STATE OF NORTH CAROLINA  
DEPARTMENT OF TRANSPORTATION

April 27, 2010

SUBJECT: Lee County, US 421-NC 87 Sanford Bypass from existing US 421 northwest of Sanford to existing NC 87 southeast of Sanford (R-2417C) and from west of SR 1400 to west of US 1-15-501 (R-2417AA); T.I.P. Number R-2417C and R-2417AA; Federal-Aid Project STPNHF-421(2); WBS No. 34431.1.1

Attached are the modifications to the U.S. Army Corps of Engineers Section 404 Individual Permit 404 and N.C. Division of Water Quality Section 401 Individual Water Quality Certification for the above referenced project. All environmental permits have been received for the construction of this project.

Permit Drawing  
Sheet 28 of 41

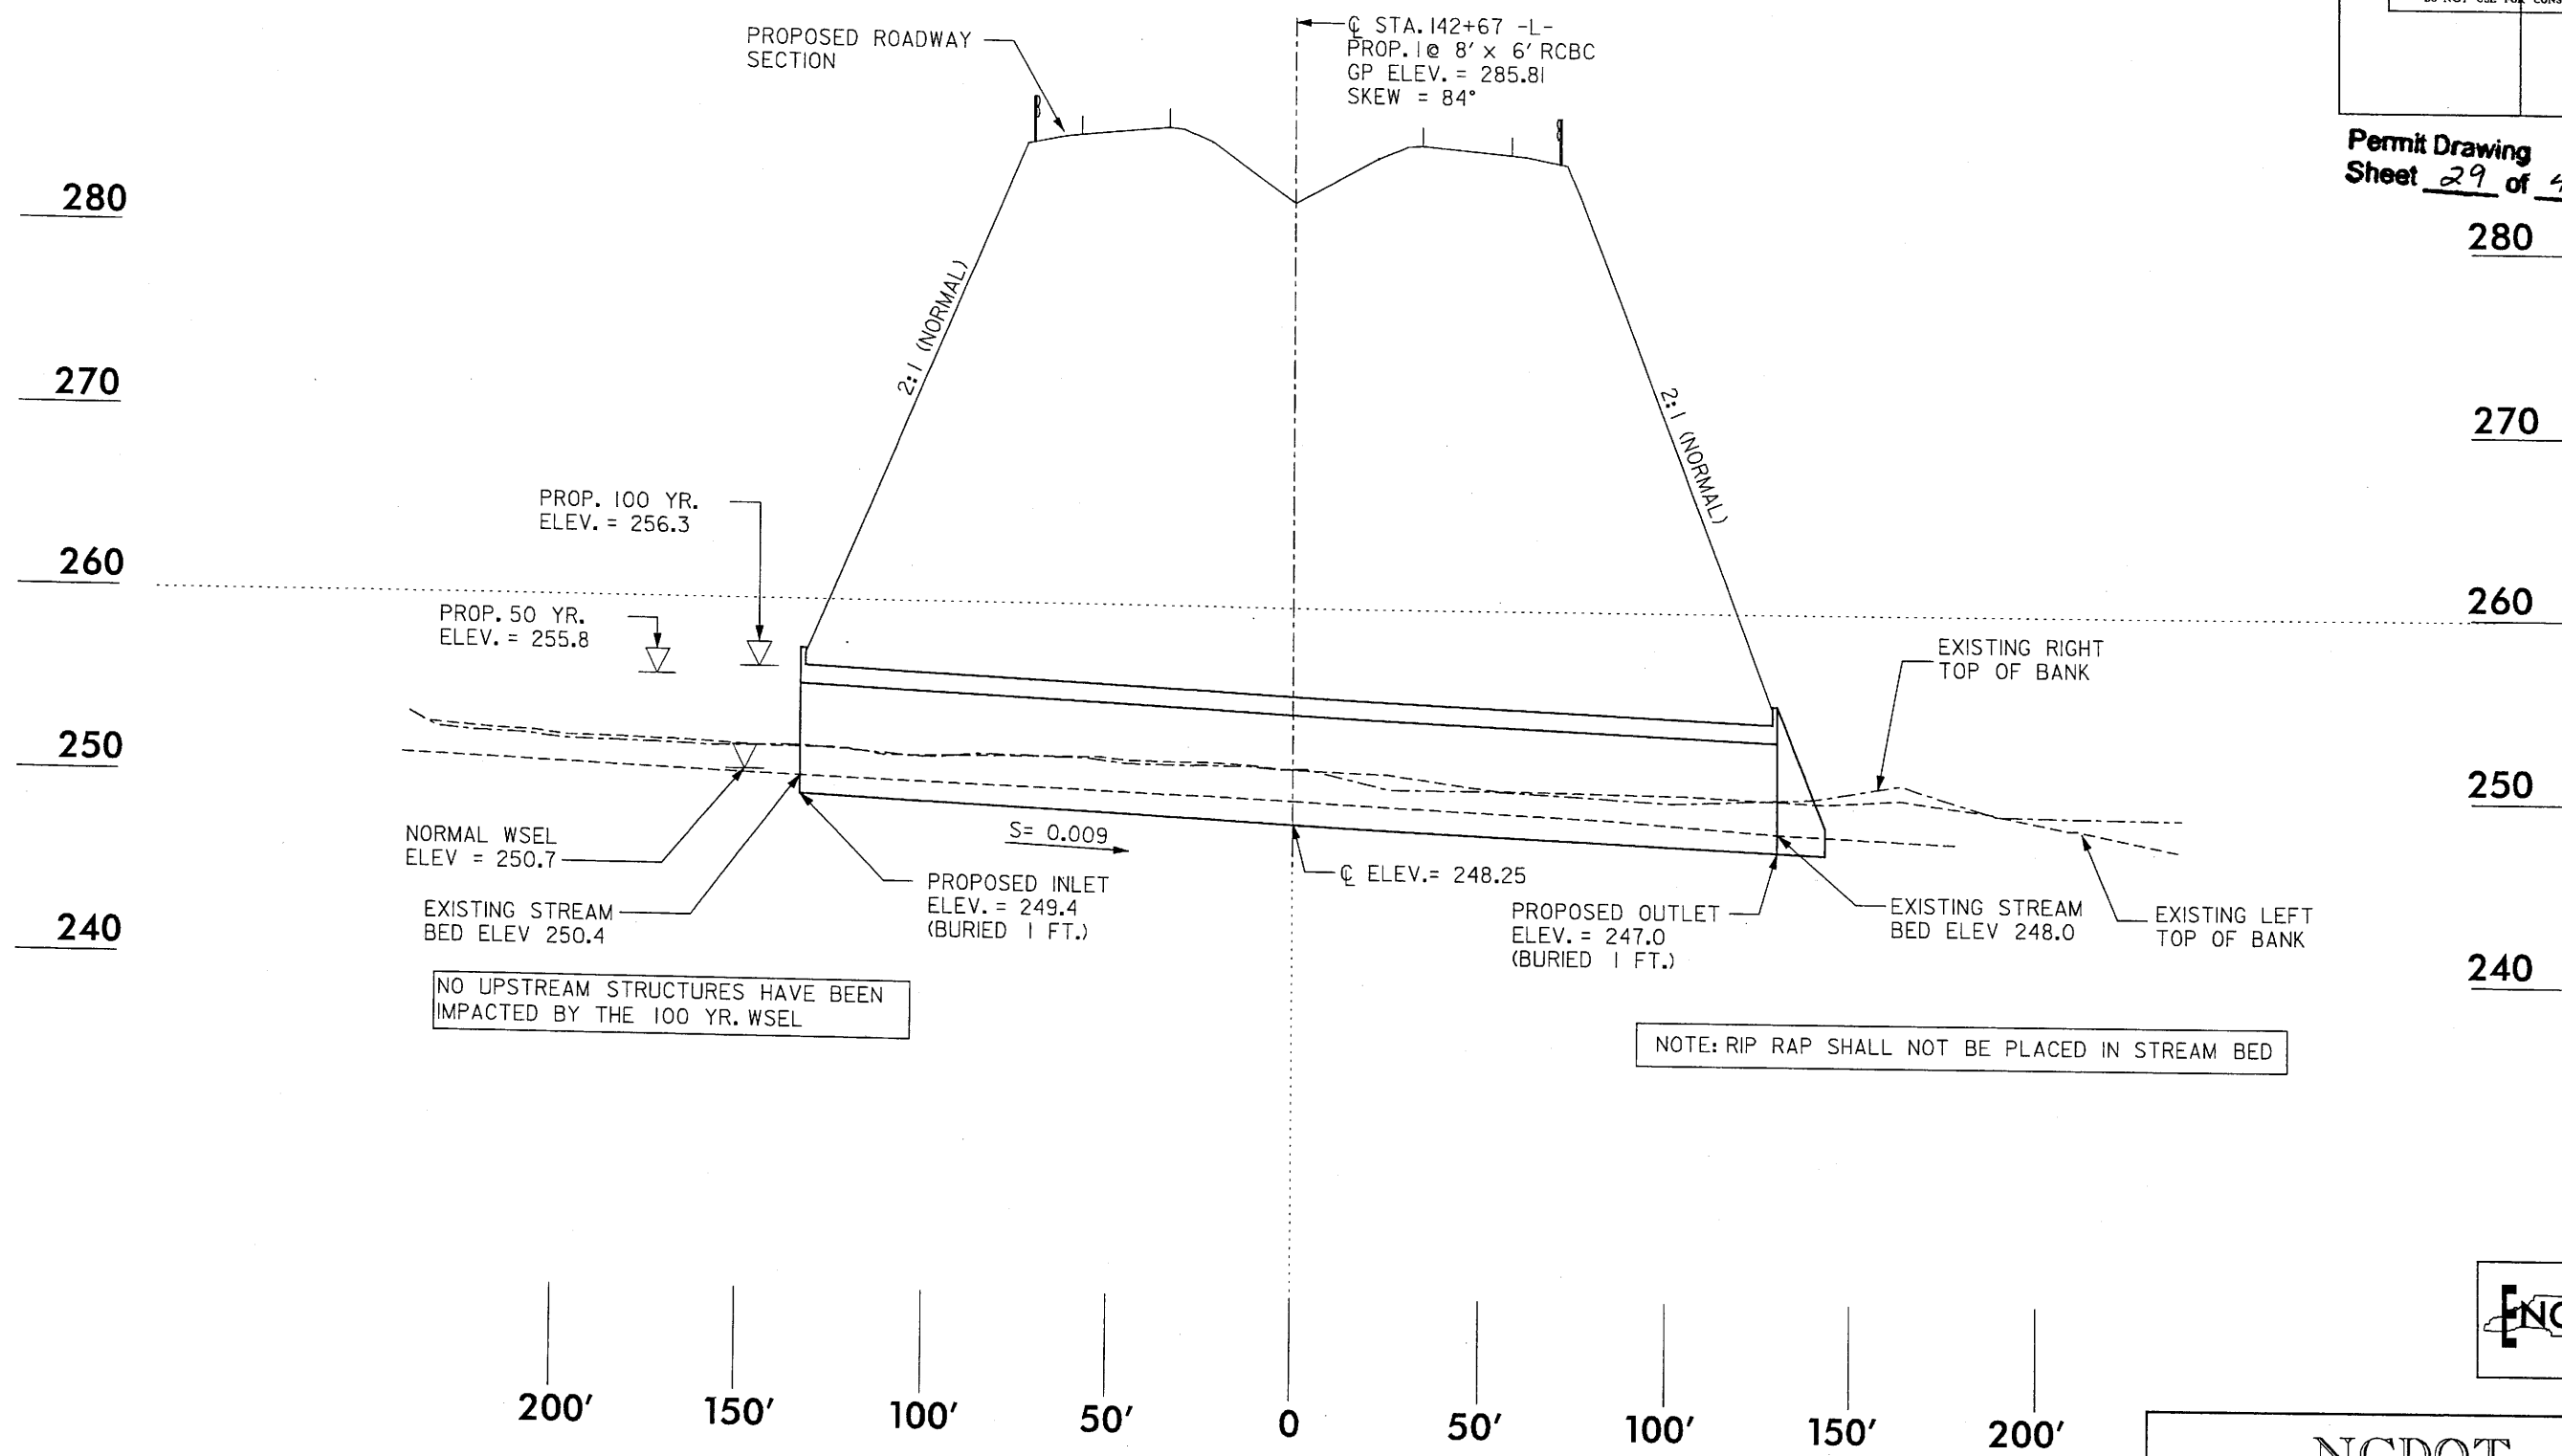
6. Class B riprap is proposed for the channel relocation at Permit Site 14 (Permit Drawing 28 of 31) and the outfall from the associated ditch line. Riprap shall not be placed in the active thalweg channel or placed in the streambed in a manner that precludes aquatic life passage. Bioengineering boulders or structures should be properly designed, sized and installed. In addition, riprap shall be of sufficient size such that it is not carried downstream by normal stream flow.

Permit Drawing  
Sheet 30 of 41

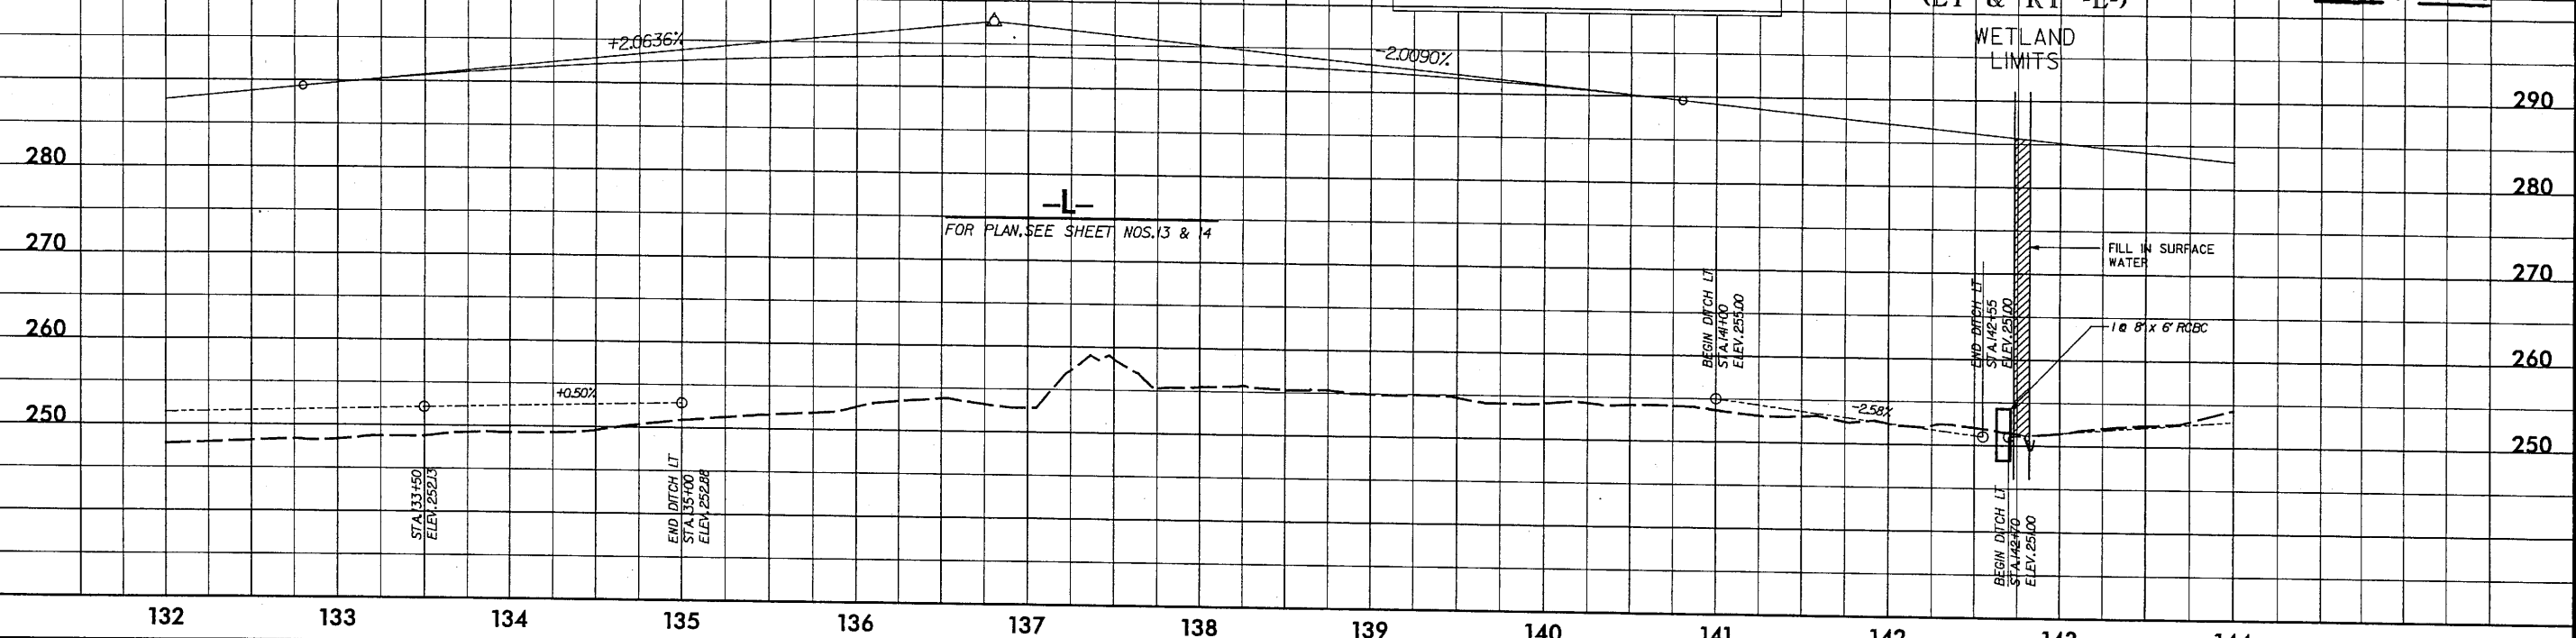
1. A sill shall be placed on one of the box culverts to maintain the natural stream dimension at Permit Sites 2 (Permit Drawing 16 of 31) and 7 (Permit Drawing 30 of 31).
